Exhibit 1: Brooks Atkinson Theater

Exhibit 1B: Architectural Modifications

Exh. 1B Architectural Modifications to Brooks Atkinson Theater

1. BROOKS THEATER
ORCHESTRA LEVEL ACCESSIBLE TOILET ROOM PLAN

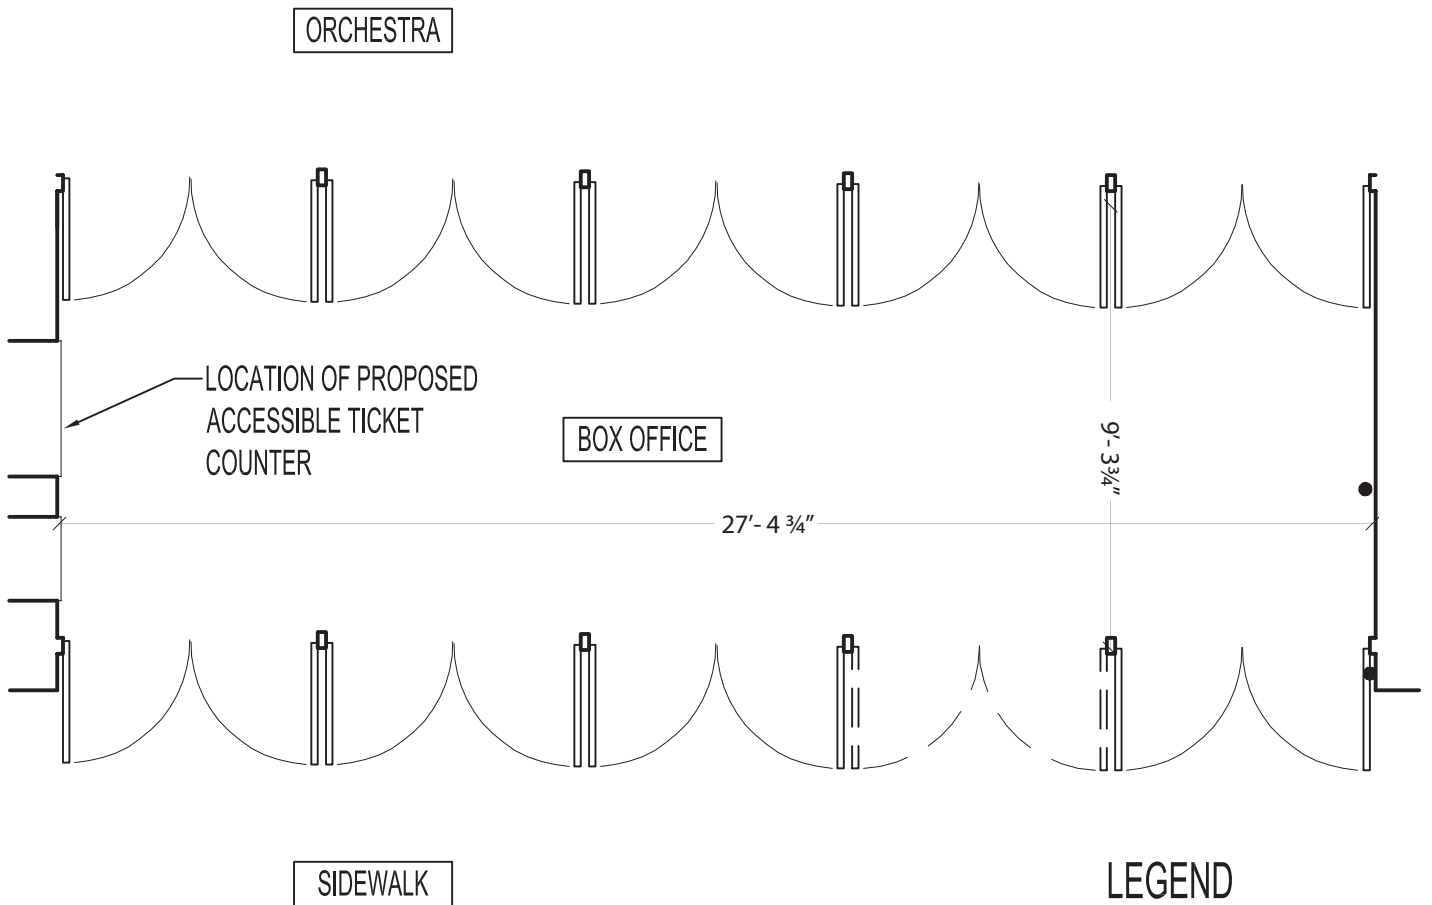
45	Orchestra Level (Accessible Toilet Room)	The water closet is 22" from centerline to side wall.	The centerline of the water closet is more than 18" from the side wall.	4.1.3(11) 4.22.4 4.17.2 4.16 Fig.30	Defendant will relocate water closet at compliant distance from the side wall.
46	Orchestra Level (Accessible Toilet Room)	Missing signage.	There is no raised lettering and Braille room identification sign provided at this unisex single user toilet room	4.1.3(16)(a) 4.30.1 4.30.4 4.30.5 4.30.6	Defendant will provide compliant signage.

1. BROOKS THEATER
BOX OFFICE/ENTRANCE PLAN

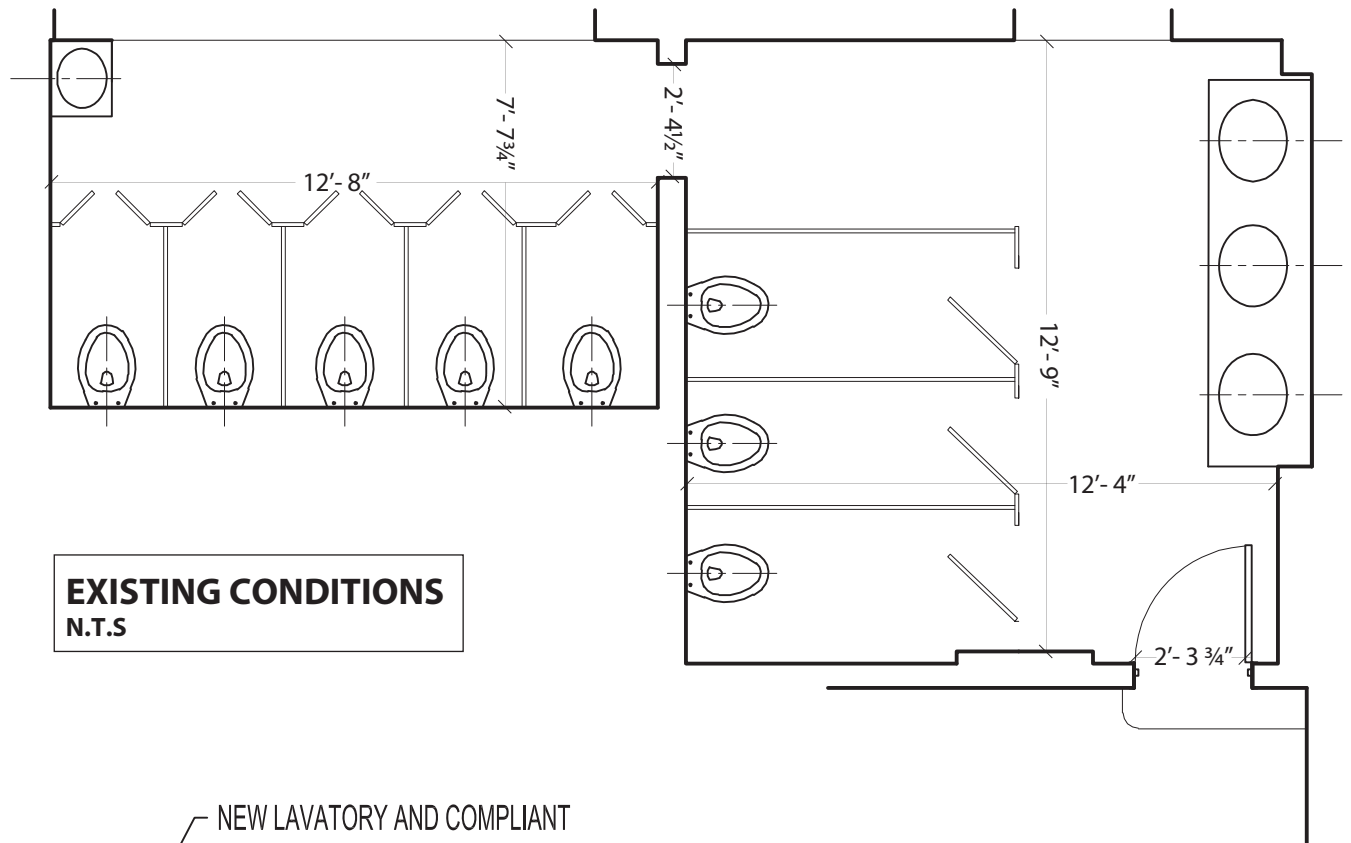
36	Box Office	There is no folding armrest signage.	No signage is provided at the ticket office notifying patrons of the availability of seating with folding or removable armrests.	4.1.3(19)(a)	Defendant will provide compliant signage.
37	Box Office		No signage is provided at the ticket office notifying patrons of the availability of an assistive listening system.	4.1.3(19)(b) 4.33 4.30.7, Fig. 43(d)	Defendant has provided ALS, and will continue to do so. Defendant shall post signage advising patrons of the availability of ALS.
38	Box Office	The ticket sales counters are 41" AFF and 44" AFF.	Sales, service, or information counter is higher than 36" AFF at cash register(s) for sales or distribution of goods or services to the public.	7.2(2) 4.3	Defendant will provide compliant ticket counter.

1. BROOKS ATKINSON THEATER
BALCONY LEVEL WOMEN TOILET ROOM PLAN

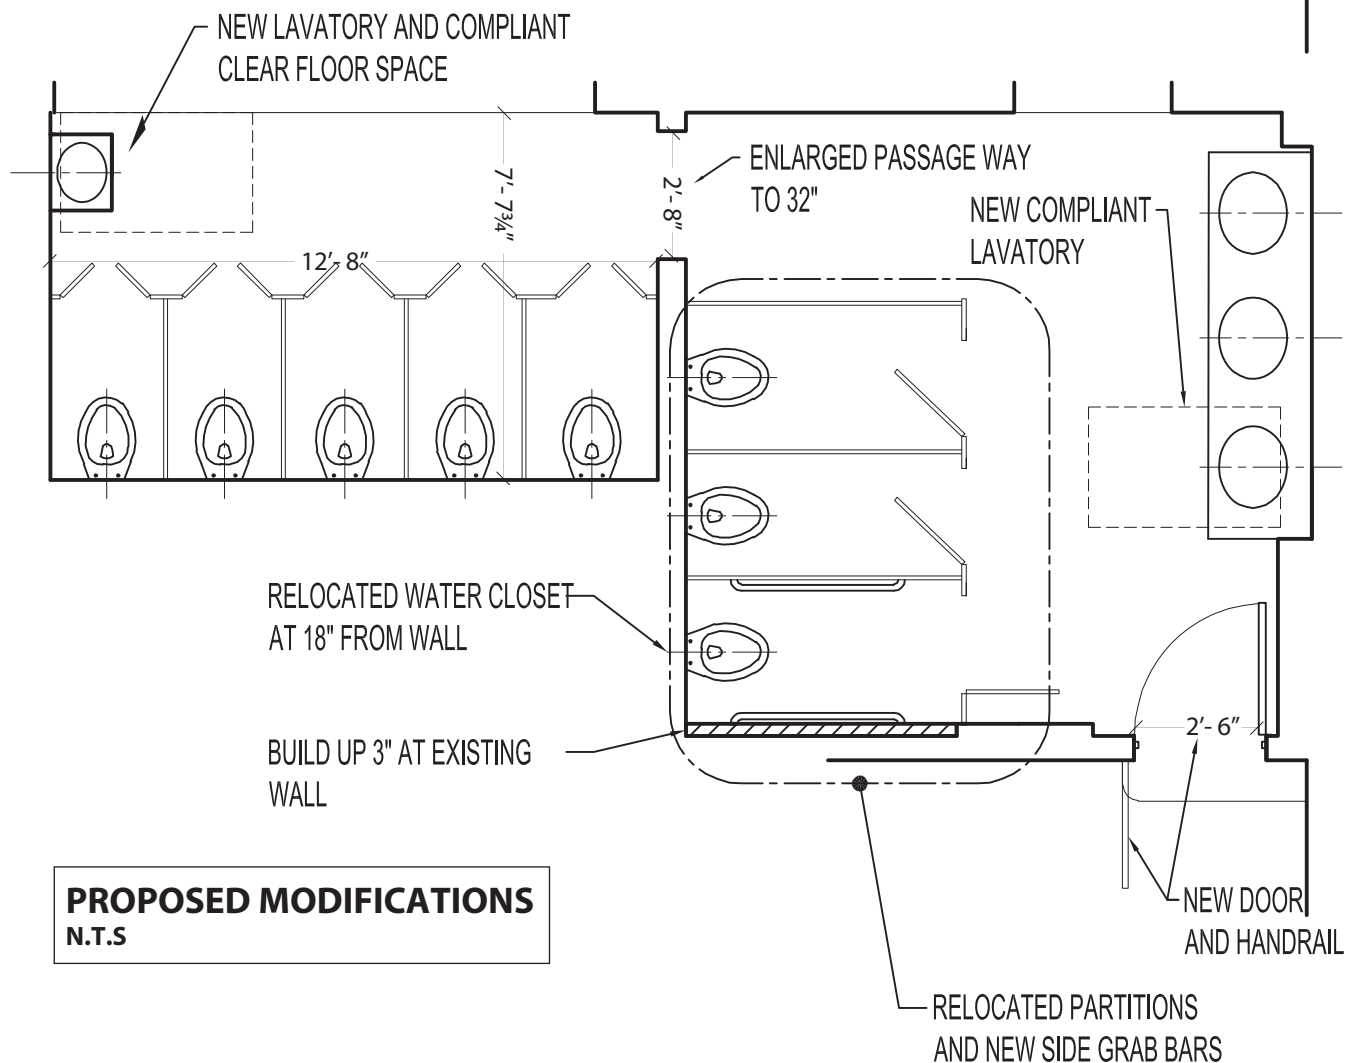
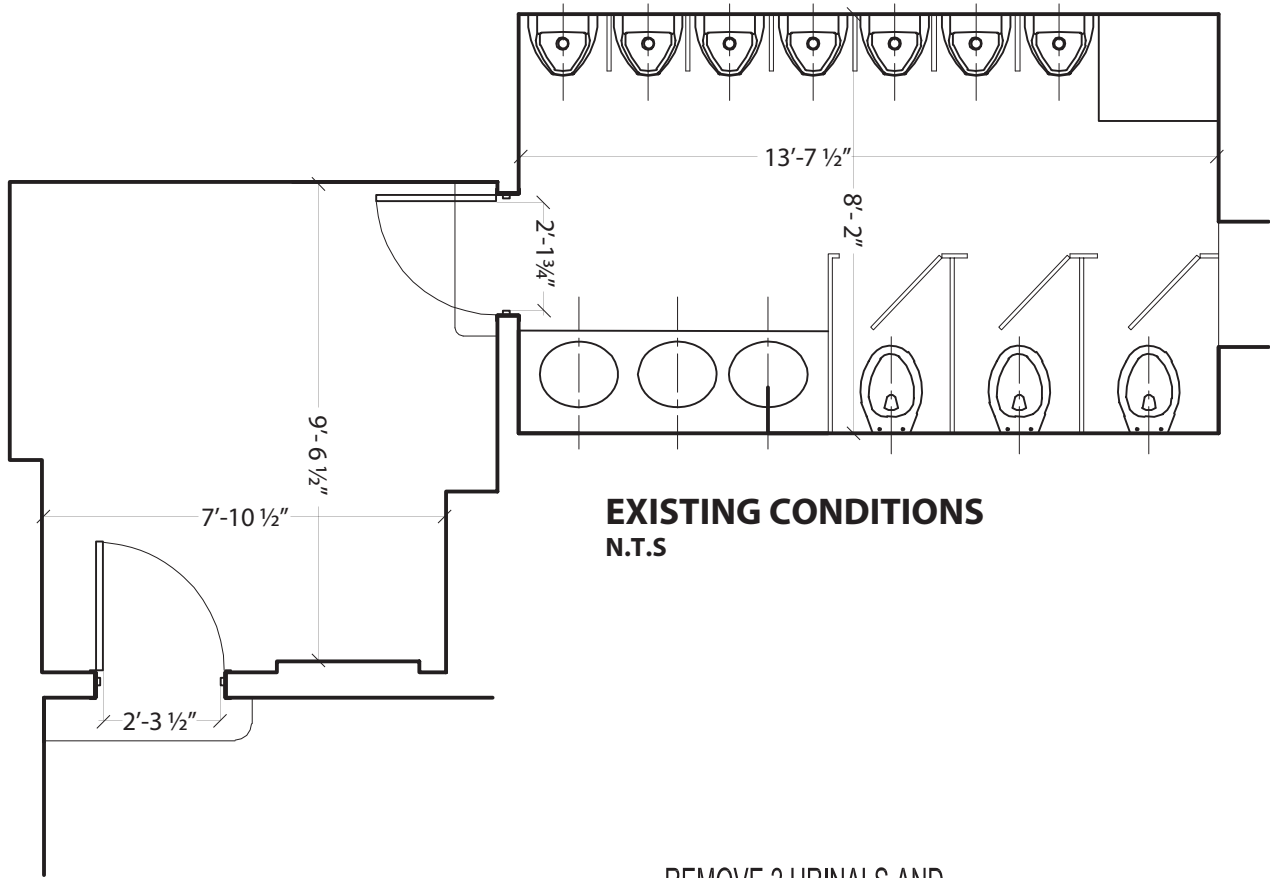
30	Women's Toilet Room Adjoining Toilet Room (Balcony Level)	Lavatories in the adjoining toilet room provide 27" AFF knee space at front edge and 24" AFF at 8" back with the rim at 31" AFF.	The wall hung lavatories have less than the required knee clearance (29" minimum AFF at front, 27" minimum AFF at 8" deep).	4.1.3(11) 4.22.6 4.19.2, Fig. 31	Defendant will provide compliant lavatory.
31	Women's Toilet Room (Balcony Level)		There is no raised lettering and Braille room identification sign provided at this gender specific multi-user toilet room.	4.1.3(16)(a) 4.30.1 4.30.4 4.30.5 4.30.6	Defendant will provide compliant signage.
32	Women's Toilet Room (Balcony Level)	The paper towel dispenser is 49" AFF above a 16" deep round waste receptacle.	Towel dispenser is mounted outside of reach range.	4.1.3(11) 4.22.7 4.27.3	Defendant will provide compliant mounting height of dispenser.

**1. BROOKS ATKINSON THEATER
BALCONY LEVEL MEN TOILET
ROOM PLAN**

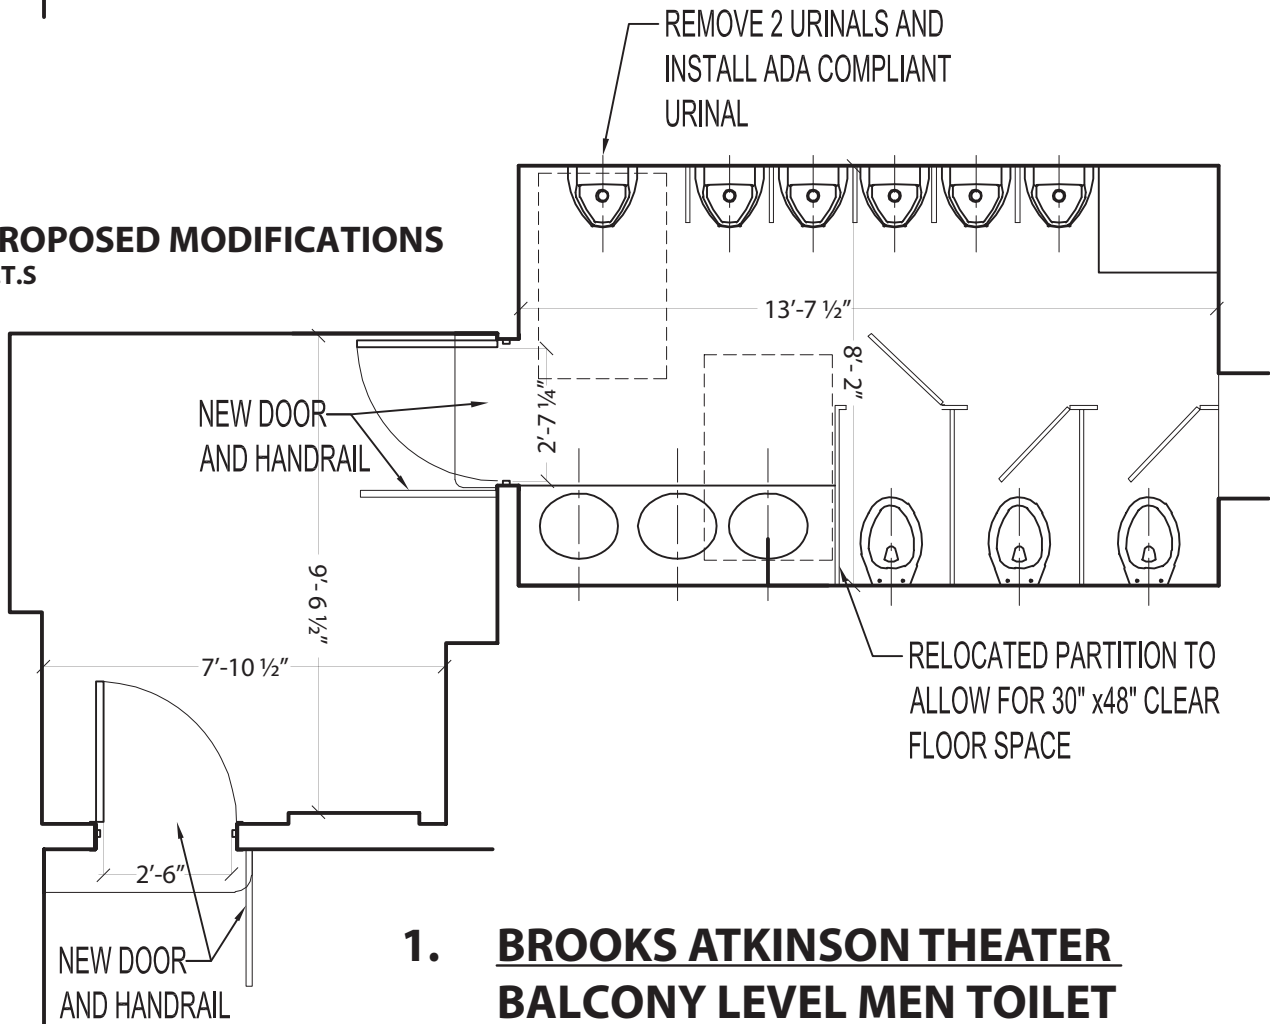
14	Men's Toilet Room (Balcony Level)	The door requires 8 pounds of force to open. This door is binding in its frame and does not close.	The main toilet room entry door is non fire-rated and requires more than 5 pounds of force to open.	4.1.3(7)(c) 4.13.10	Defendant will provide compliant door.
15	Men's Toilet Room (Balcony Level)	Public pay telephone is 64" AFF with side approach only.	The operable parts of the public pay telephone are outside reach range (48" AFF maximum for forward approach and 54" AFF maximum for parallel approach).	4.1.3(17) 4.31 4.30.7 Fig. 44 4.2.4 4.2.5 4.2.6 4.4	Defendant will remove pay telephone.
16	Men's Toilet Room (Balcony Level)		There is no raised lettering and Braille room identification sign provided at this gender specific multi-user toilet room.	4.1.3(16)(a) 4.30.1 4.30.4 4.30.5 4.30.6	Defendant will provide compliant signage.
17	Men's Toilet Room (Balcony Level)	The drinking fountain in the men's lounge is 40" AFF to the spout outlet. The control is located at the top of the drinking fountain at the back side.	There is only one drinking fountain on this floor and it does not meet the requirement to provide service to people who use wheelchairs as well as to those who have problems bending or stooping.	4.1.3(10)(a) 4.15 Fig.27a	Defendant will provide compliant drinking fountain.

**2. GERSHWIN THEATER
NORTH ROTUNDA - MEN'S TOILET ROOM PLAN**

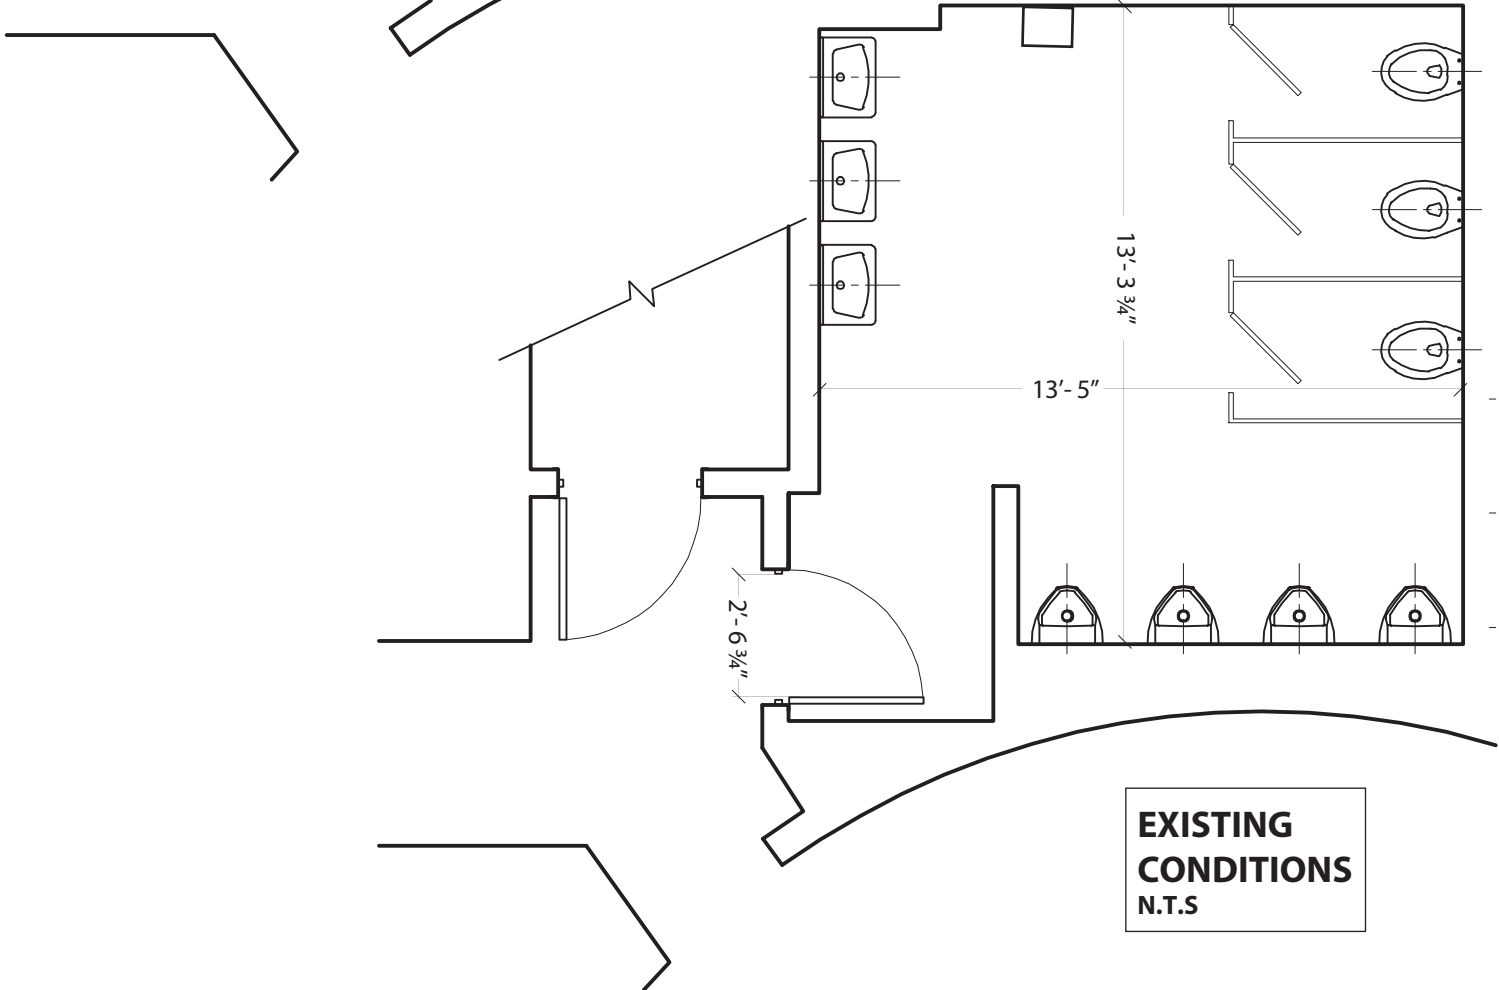
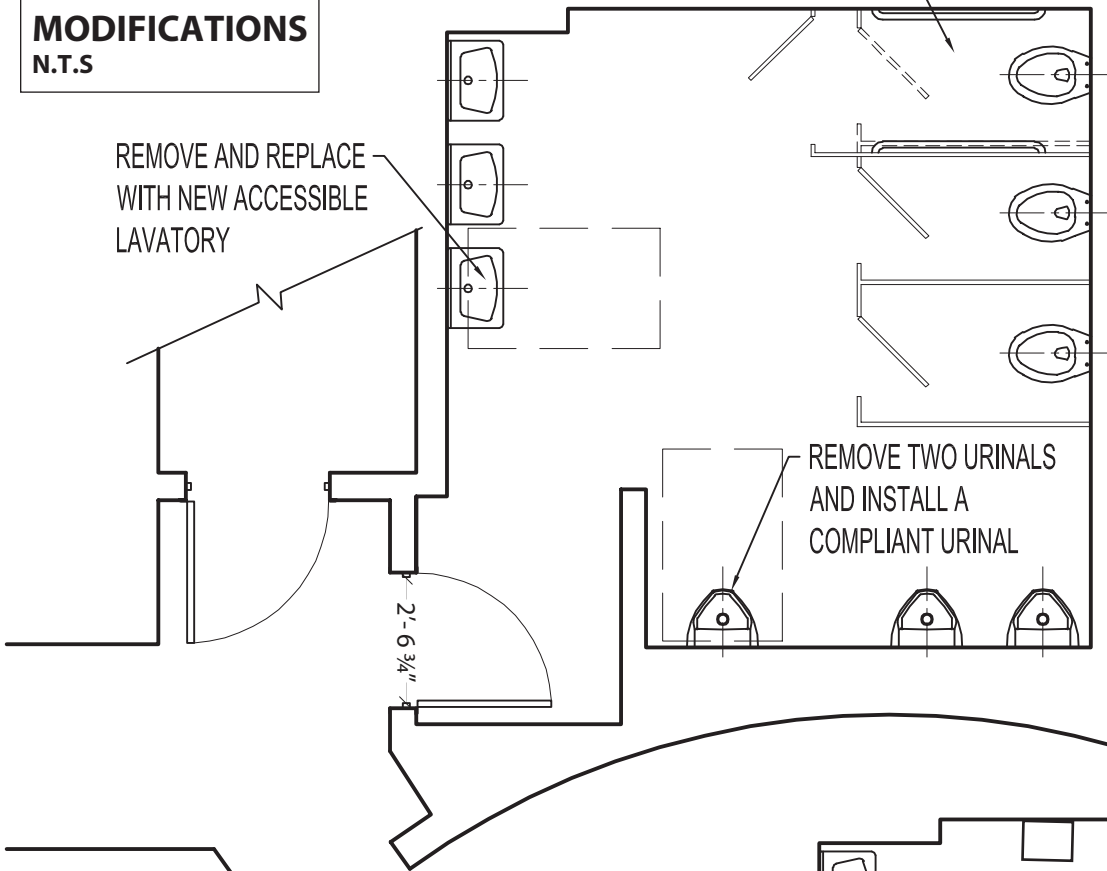
REMOVE AND REPLACE
WITH NEW ACCESSIBLE
LAVATORY

REMOVE TWO URINALS
AND INSTALL A
COMPLIANT URINAL

Line #	Location Description	Existing Condition	Barrier Description	1991 Standards Reference	Architectural Modification
56	North Rotunda (Men's Toilet Room)	The non-fire rated door provides 31" of clear width.	Remove existing door, widen opening, and install new door that provides the minimum required clear width. Coordinate with maneuvering clearance requirements.	4.1.3(7)(c) 4.13.5 Fig. 24 4.13.9 4.13.10 4.13.11	Defendant will provide compliant door as far as readily achievable at 31".
57	North Rotunda (Men's Toilet Room)	Door hardware requires tight grasping, pinching.	Remove existing operating hardware and install compliant hardware.	4.1.3(7)(c) 4.13.9	Defendant will provide compliant hardware.
58	North Rotunda (Men's Toilet Room)	Hot water is available at lavatory and hot water supply pipes and/or drain pipes are not insulated or covered.	Insulate hot water supply and drain pipes. Ensure that all other sharp or abrasive surfaces are properly covered or filed smooth.	4.19.4	Defendant will provide compliant insulation.

59	North Rotunda (Men's Toilet Room)	There is a trash can in the door maneuvering clearance.	Remove nonpermanent obstruction.	4.13.6 Fig. 25(a-f)	Defendant will remove non permanent obstruction.
60	North Rotunda (Men's Toilet Room)	The door requires 8 pounds of force to open and travels from 700 open to within 3" of the latch in 2.5 seconds.	Adjust the existing closer to provide compliant speed and force.	4.1.3(7)(c) 4.13.10	Defendant shall adjust existing door closer for compliance.
61	North Rotunda (Men's Toilet Room)	The threshold is 3/4" tall with a "bull nose" bevel.	Remove the existing threshold and install a compliant threshold.	4.1.3(7)(c) 4.1.6(3)(d)(ii) 4.13.8 4.5.2 Fig. 7(c,d)	Defendant will lower threshold to compliant height.
62	North Rotunda (Men's Toilet Room)	There are 3 wall mounted lavatories 27.5" knee space at the front and 25" at 8" back.	Raise the existing compliant wall mounted fixture to the required height.	4.1.3(11) 4.22.6 4.19.2 Fig. 31	Defendant will install compliant lavatory.
